## Kirby Morgan Dive Systems, Inc.®

### Bulletin #3 of 2017. November 17, 2017

### **Change to Product Bulletin** 250-029 Balance Piston Replaced / 550-549 Balance Spacer Color Change/ New 250-065 Washer Required (Scuba Only)

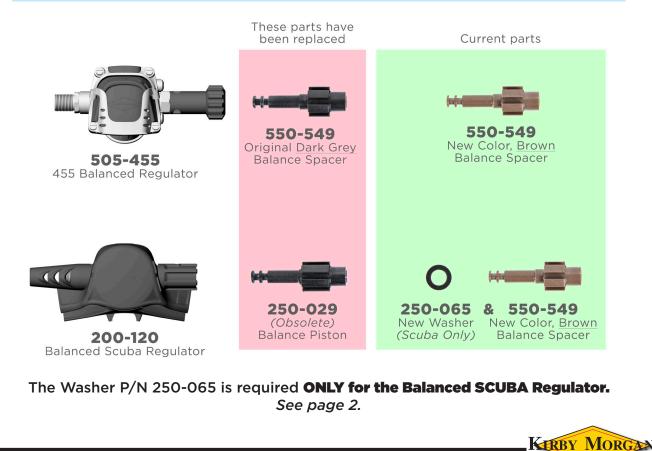
- The Balance Spacer, P/N 550-549 will no longer be dark grey in color.
- The NEW COLOR will be BROWN. NO PART NUMBER CHANGE.

The Balance Piston, P/N 250-029 is obsolete and will no longer be used in the Main Tube Assembly P/N 205-030.

Change to the Main Tube Assembly: The obsolete P/N 250-029 is replaced by the two parts below.

- The **Balance Spacer** P/N 550-549 is **brown** in **color**.
- Washer P/N 250-065 must be used when using the new color, brown Balance Spacer in the Balanced SCUBA regulator.
  (Washer NOT to be used with the original dark grey P/N 250-029)
